## ADDENDUM No. 1

**PROJECT:** Spartanburg Community College  
**Tyger River HVAC and Boiler Replacements**  
OSE Project No. H59-6315-JM  
DEVITA Project No. 25531

**DATE:** February 18, 2026

DRAWING NO.  
**A200**

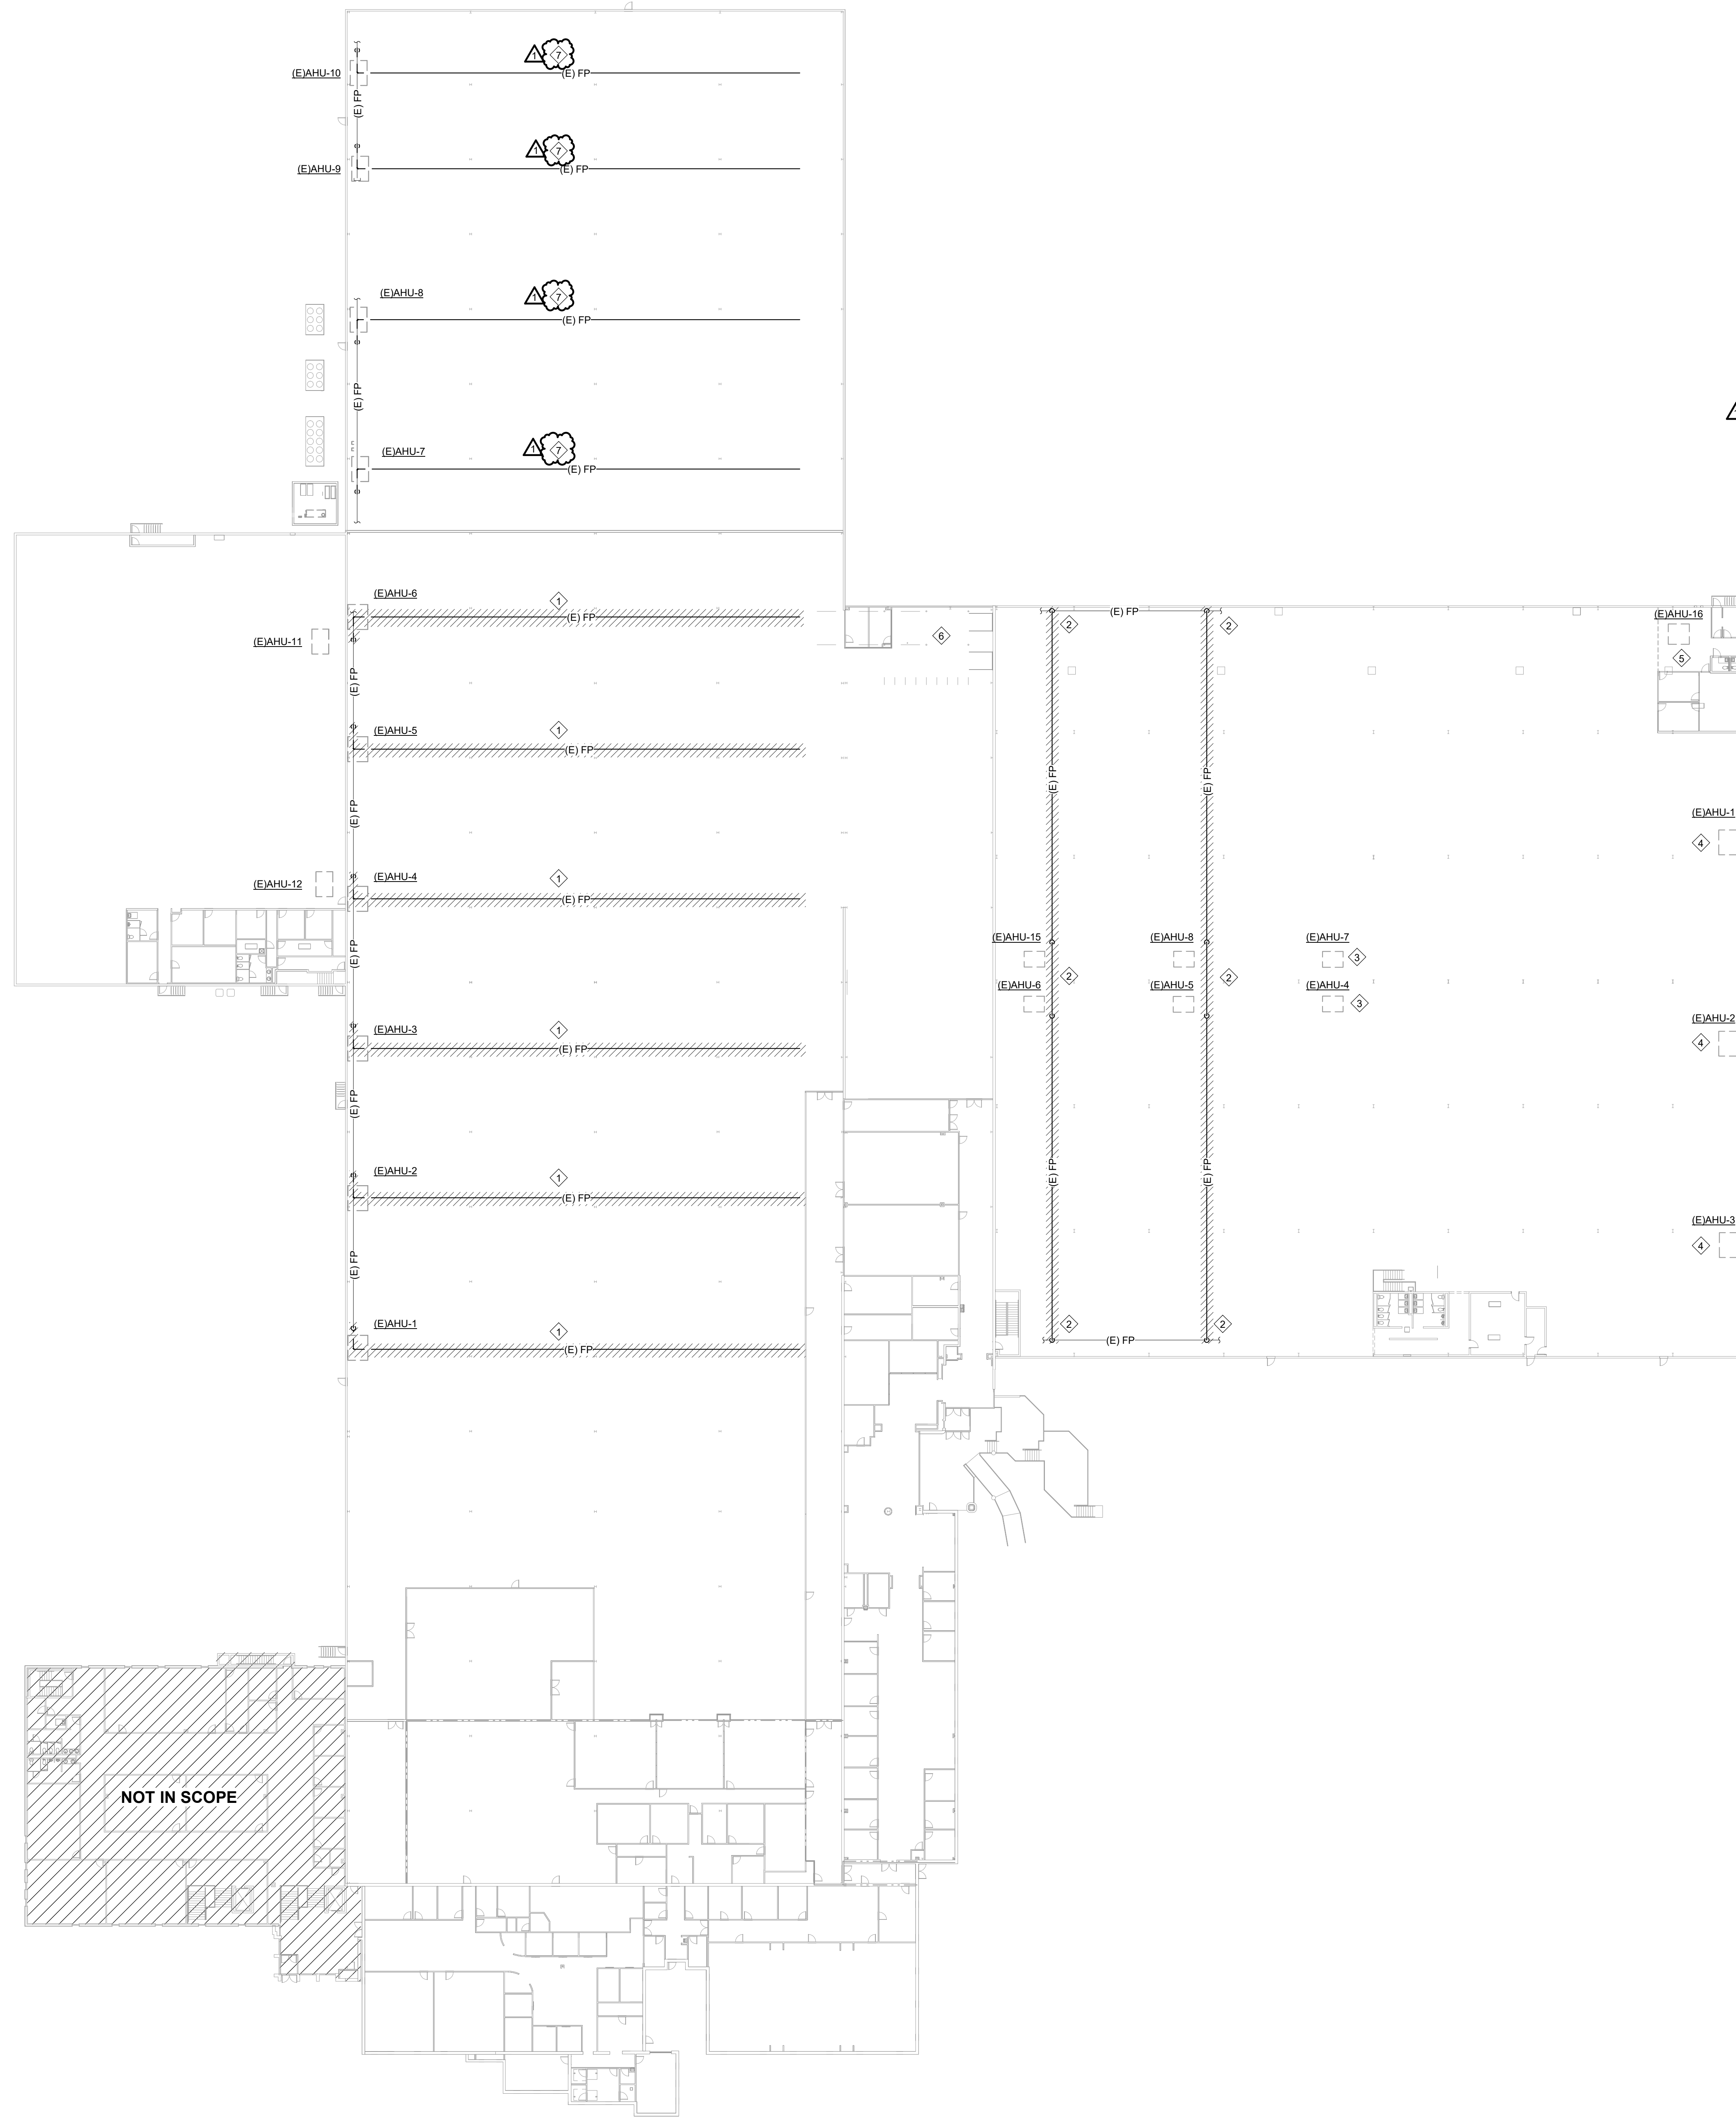
- Demolition scope updated to include more ceiling in the Ready SC area to accommodate medium pressure supply air ductwork installation.

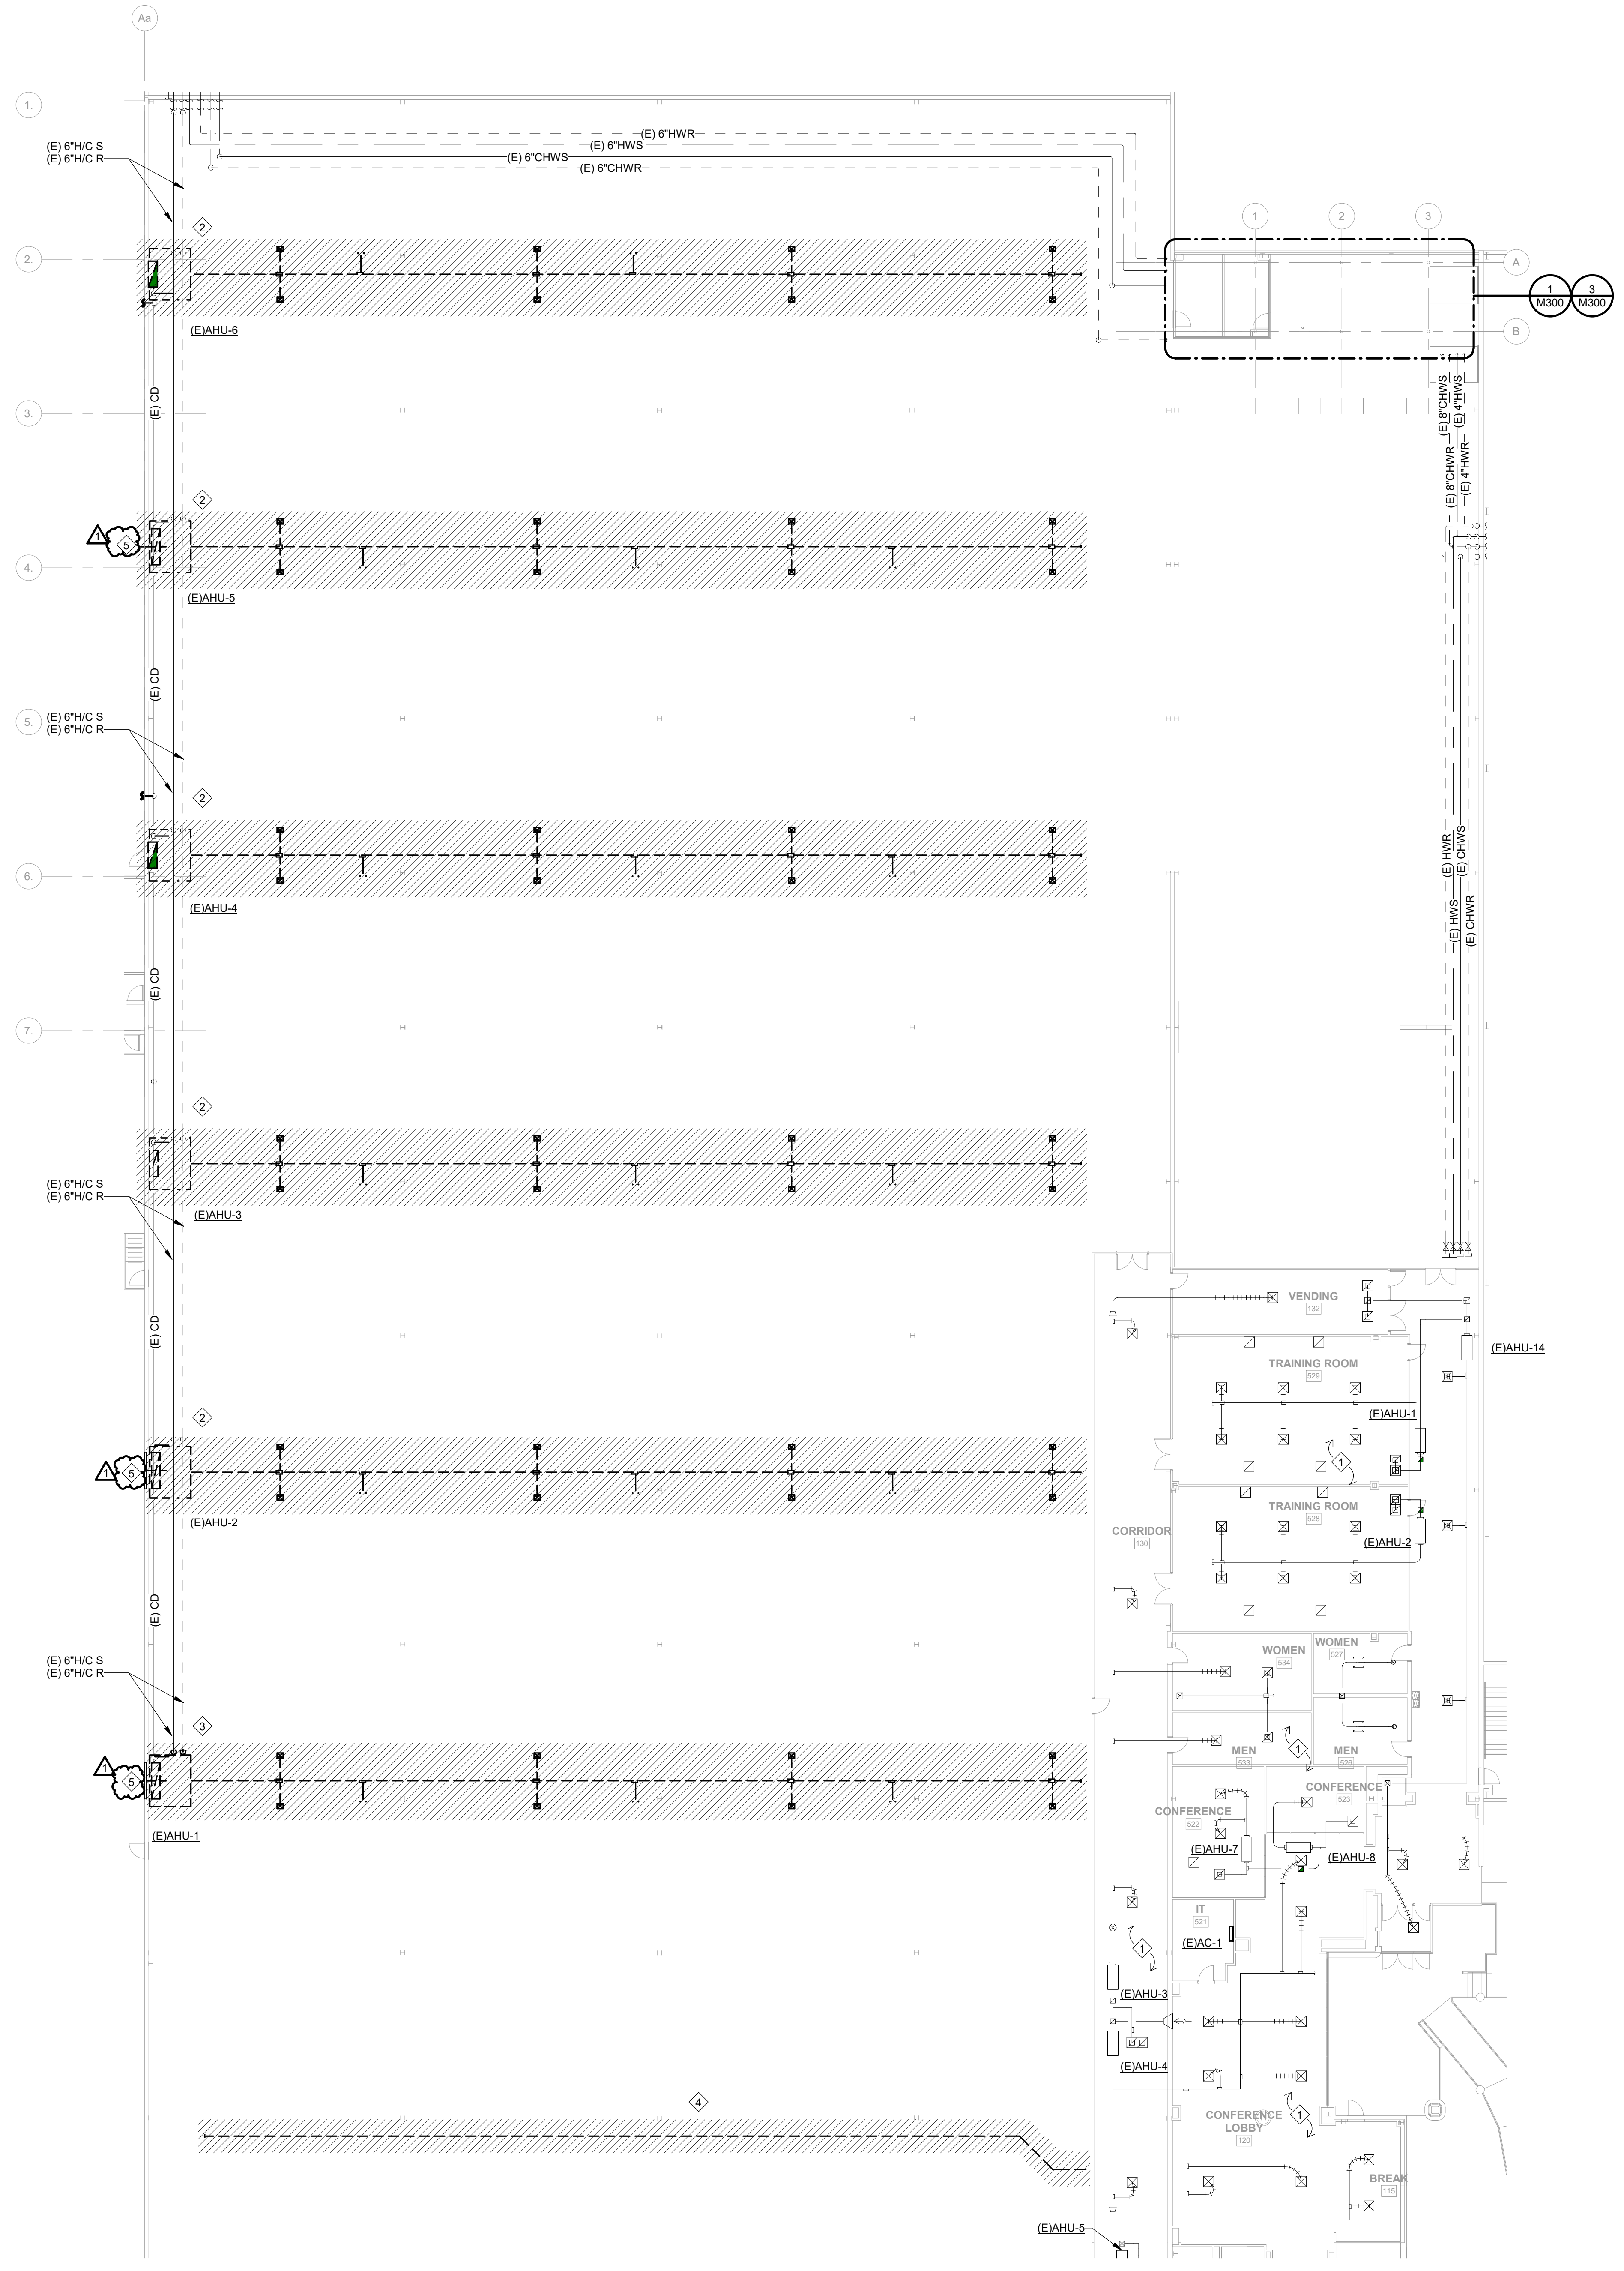
- Smoke detectors are not required in return sections of ARU-1 thru 6 per 2021 SC Mechanical Code Section 606.2 – Exception.
- Variable Air Volume Terminal Unit Schedule – Added Carrier 35E and 45N as approved equals.
- Air Handling Unit Schedule – Added Carrier 39MN as an approved equal.
- Air Rotation Unit Schedule
  - Corrected ARU-5 supply air volume.
  - Corrected ARU-4 fan HP.
  - Updated EAT and LAT for cooling and heating on units with outside air.
  - Updated notes column
  - Added Johnson Air Rotation AR-75SI, AR-55.5SI, and AR-85SI as approved equals.
  - Added unit height requirement.

15. UNIT SHALL BE 24" IN HEIGHT.
